Tube KICK

PROJECT: TUBE KICK			
STATUS: PROTOTYPE FINAL TUNING			
AUTHOR: LAURENT	DRAWING NUMBER P21-VB7-00		REV: VB8
DATE: 2015-08-18	SIZE: A4	SHEET: 1 of 1

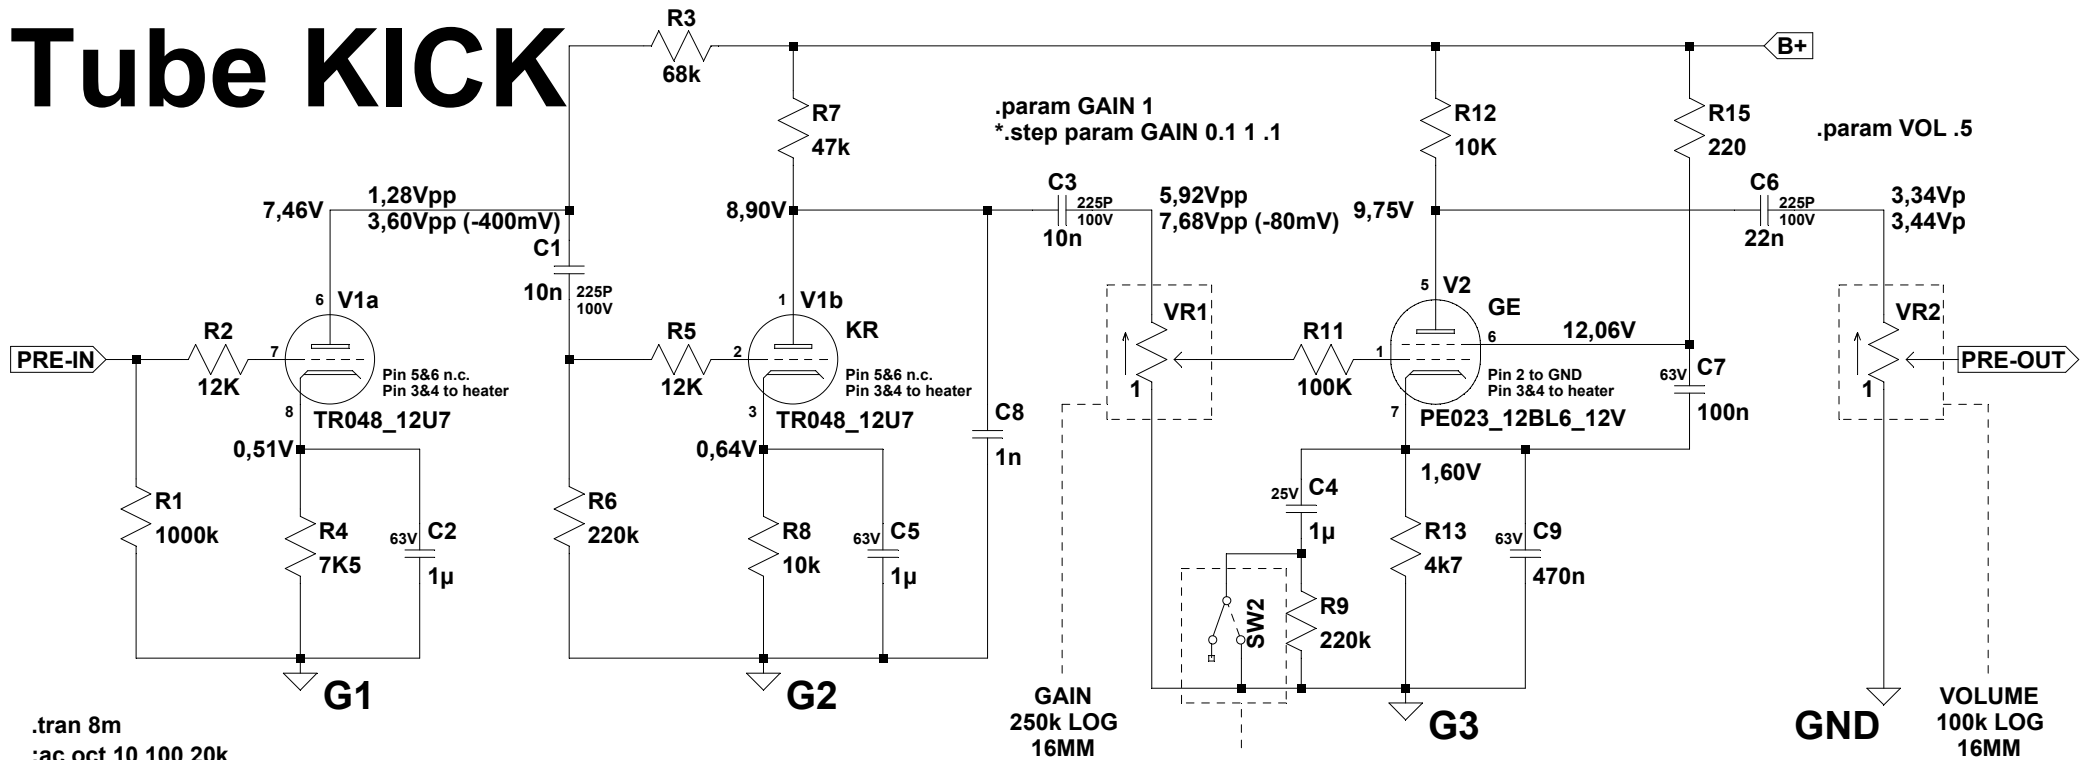
- 1- R's for LED's down to 620R
- 2- C7 connected to cathode, not GND
- 3- C4 may be increased to 2u2
- 4- Updated grounding
